RE: 5/21 Town of Peshtigo Monthly Board Meeting

SUBJECT: Response to *Interim Long Term Monitoring Plan for Groundwater and Surface Water*
JCI/Tyco FTC PFAS, 2700 Industrial Parkway South, Marinette, WI
BRRTS #02-38-580694

SUBJECT: Response to *Revised Comprehensive Alternative Water Management Plan*
JCI/Tyco FTC PFAS, 2700 Industrial Parkway South, Marinette, WI
BRRTS #02-38-580694

Attachment A: Copy of Figure 10 from JCI/Tyco's Apr. 2023 SI Status Report with Proposed and Recommended New Well Locations Identified

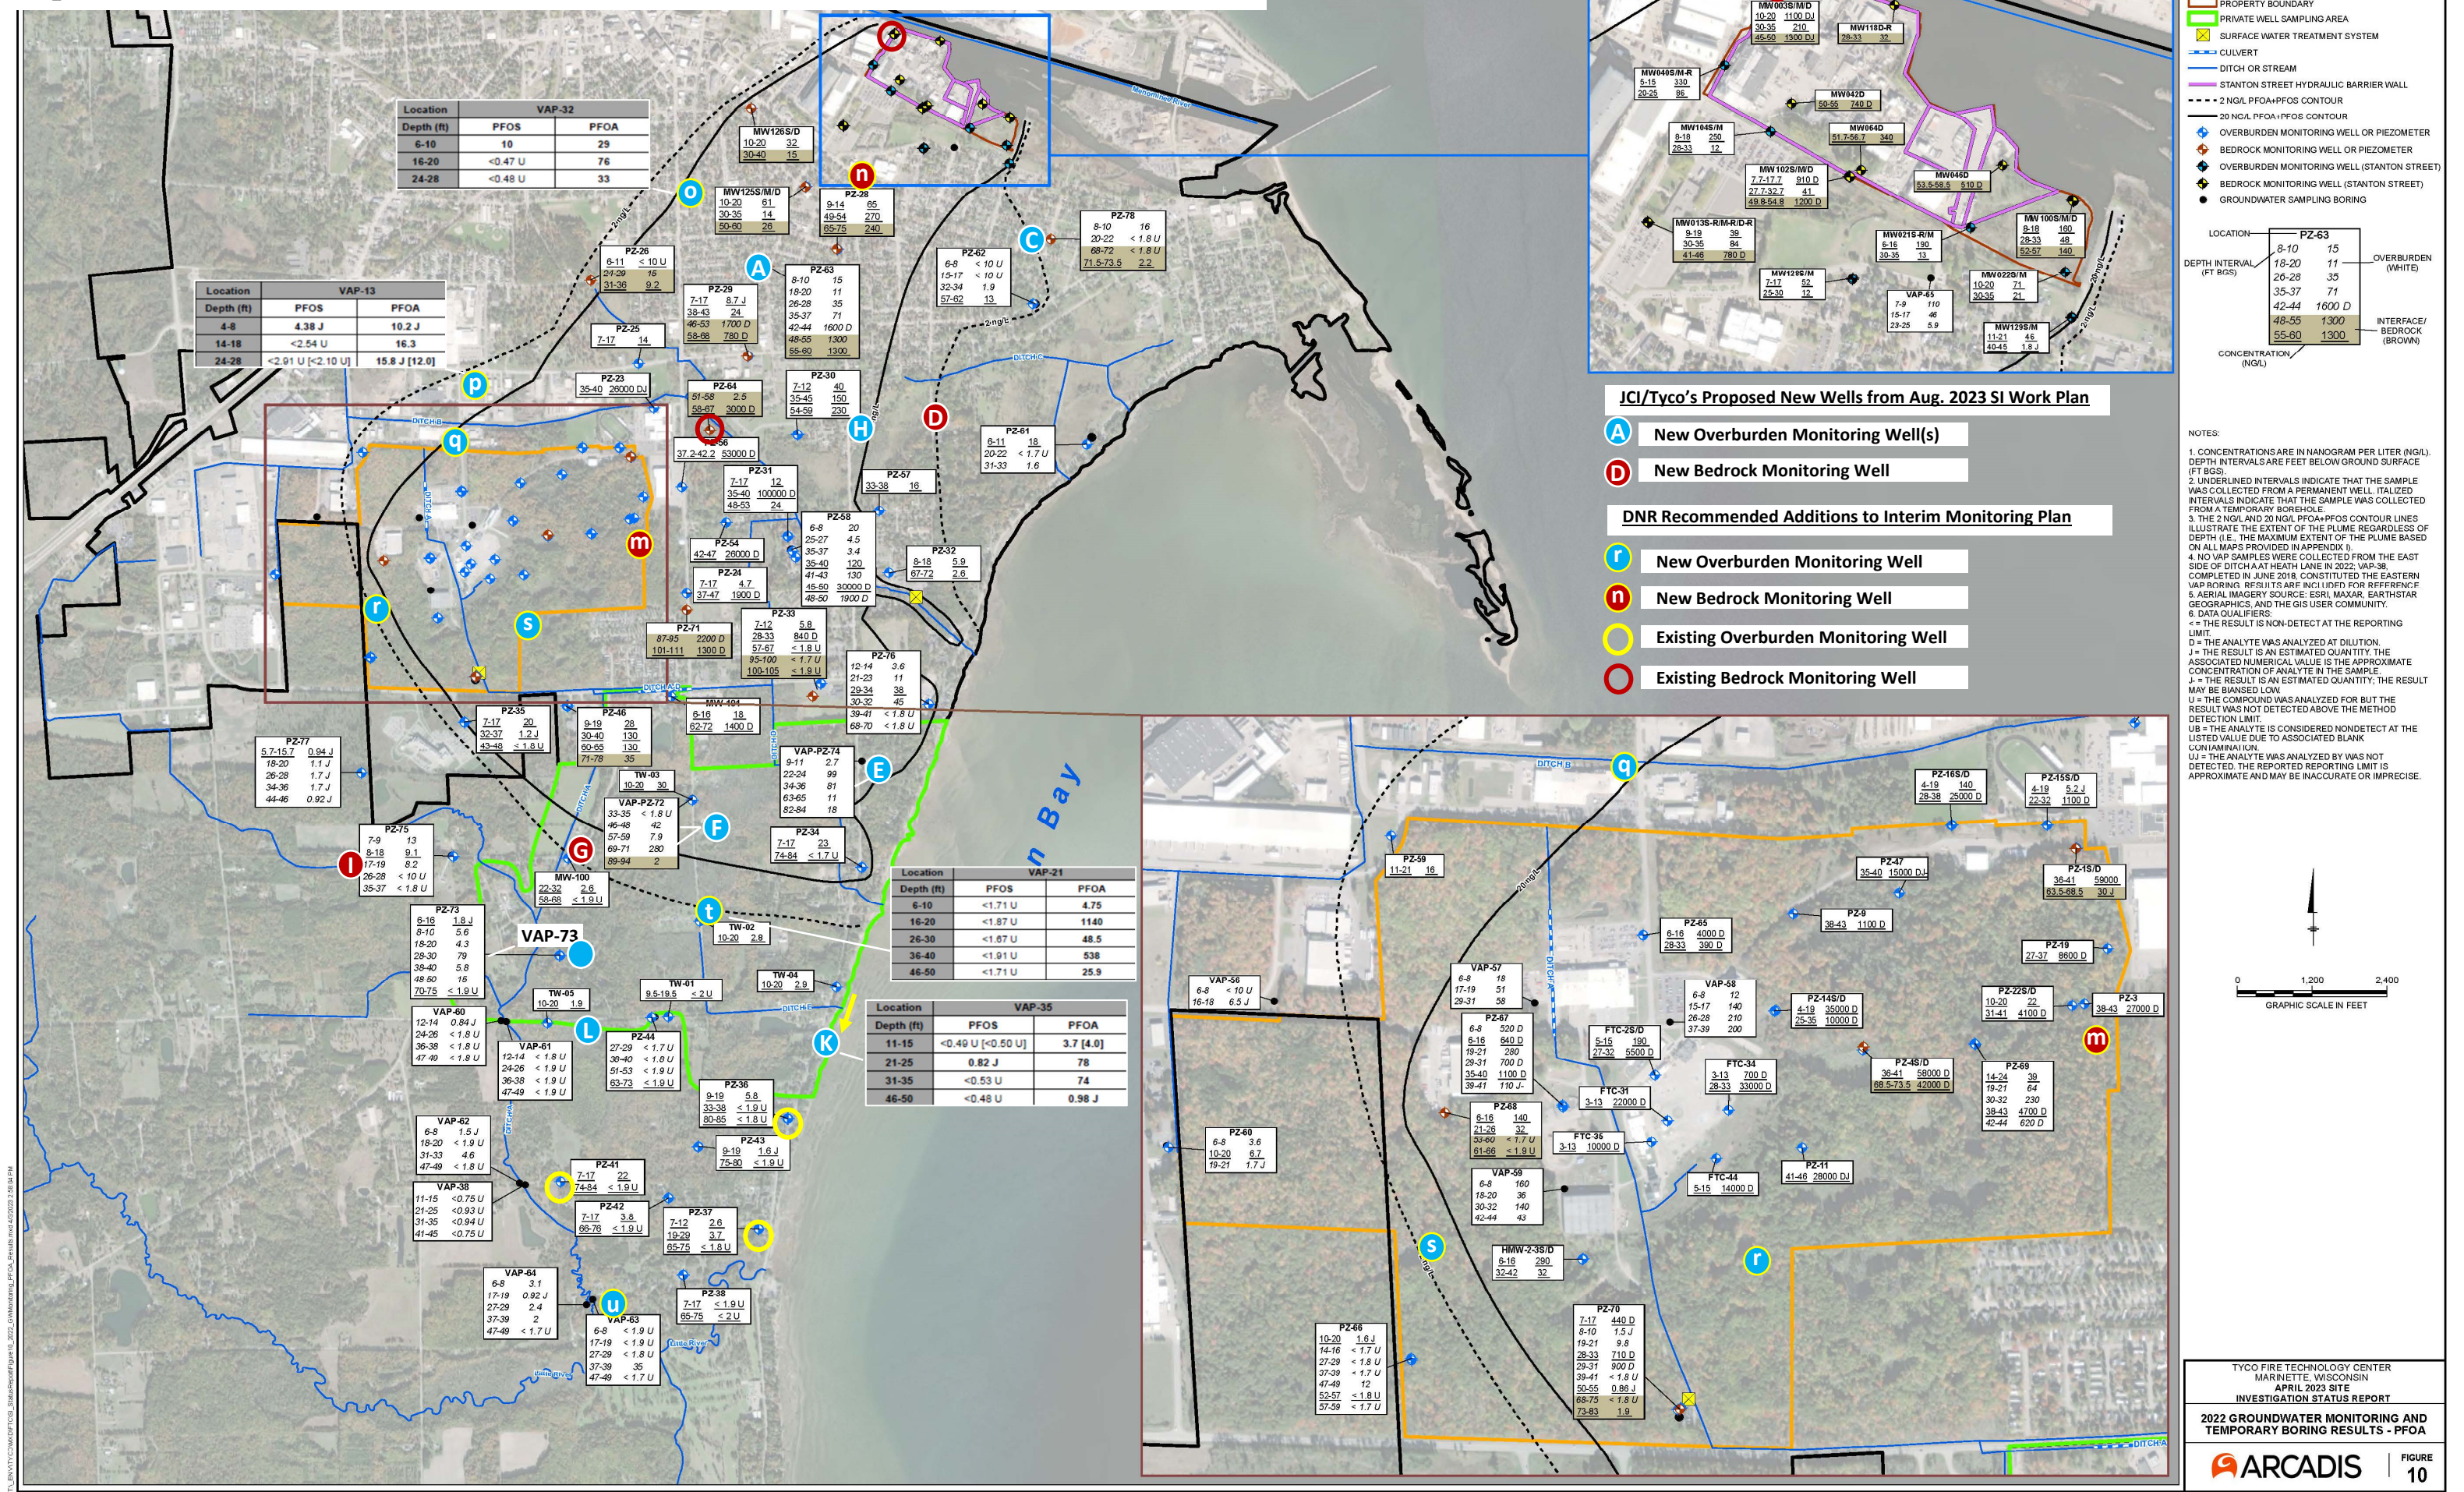
Monitoring Well Additions: The DNR recommends adding monitoring wells into the Interim Monitoring Plan, which are summarized in the **Attachment A Table and Figure**. This includes two existing bedrock monitoring wells and eight new monitoring wells in addition to the ones recommended above. The DNR also recommends adjusting the location of proposed monitoring well “K,” to be closer to vertical aquifer profile (VAP) sampling point VAP-35 (see **Attachment A Figure**).
